## **ENGINEERING CHANGE NOTICE**

ENGINE		140	CHANGE N	OHOL	
Date: 98,10,23					ECN#: 12
					-ECN#: 113
Project No.: 0204-618			Created By: ()	Checked By:	<b>##</b>
Project Name: Zo4 Fixed Step			Approved By: (proj. manager)	Approved By: (management	
Description of Change:				<del></del>

DRAWING NO. D2460

## SECTION A-A SCALE 3:5

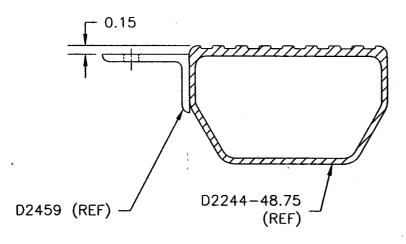
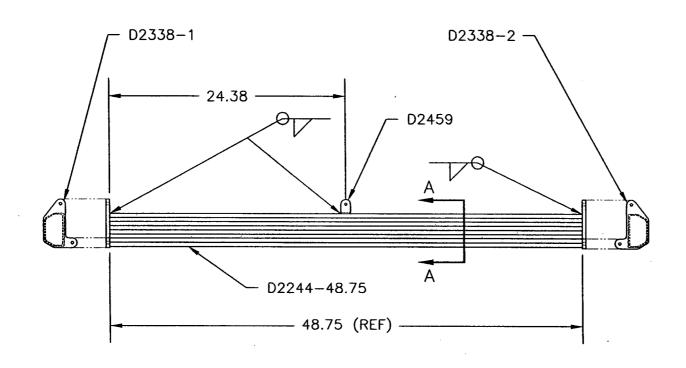
•					
Revised D2460 to Rev C in response					
Kevised Dato 10 11-1-1-1-1-1-1-1-1-1-1-1-1-1-1-1-1-1					
to TSR a 915. Added Section A-A					
to clarify, placement of D2459.					
/ ' ·					
Notification/Acceptance	Affecte	ed 🗸		Authorization	
QA	1	<del></del>			
Production	1	7	1	2015	
Planning	1	7	1 12K	A915	
Marketing	N	IA	1		
		سنشه		<u>,</u>	
Engineering Actions	Yes	No	Responsible	To happen by:	Complete
Update Blue File		<b>V</b>			
Update Pink File		<u> </u>			
Update D-Part Master Binder	$\checkmark$		Cl <sup>3</sup>	98,10,23	98,1423
Update Grey Project Binder	$\overline{\mathbf{A}}$		(P	98.10,73	88.10,23
Update DEO Binder		$\sqrt{}$			
Update Master Document List		$\sqrt{}$			
Update Drawing Approval Record		$\checkmark$			
Notify TCA of Change		V			
Notify FAA of Change		$\checkmark$			
Notes:	,		A	^ .

ADDED

SECTION A-A

(TSR

A915)

- Finishing notes were not on day - added at this revision Ensure that IPP is in agreement					
1		V			
1					
ı					
İ					
1
